## RHODE ISLAND CONTRACT NO.2019-CH-026

#### **Broad St Regeneration**

#### NOTICE TO PROSPECTIVE BIDDERS

ADDENDUM NO. 3 Prospective bidders and all concerned are hereby notified of the following changes in the Plans, Specifications, Proposal and Distribution of Quantities for this contract. These changes shall be incorporated in the Plans, Specifications, Proposal and Distribution of Quantities, and shall become an integral part of the Contract Documents.

BROAD STREET (ROUTE 114) REGENERATION PROJECT PAWTUCKET, CENTRAL FALLS AND CUMBERLAND, RHODE ISLAND MISCELLANEOUS DETAILS NO. 2

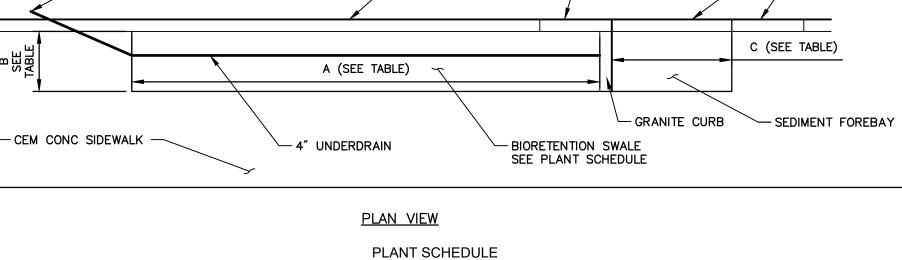
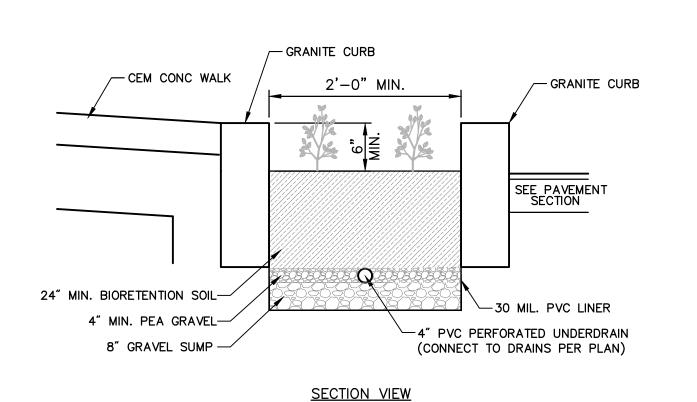
Delete Sheet 39 (R-1) in its entirety and replace it with Sheet 39 (R-2) attached to this Addendum No. 3. The sheet has been revised.
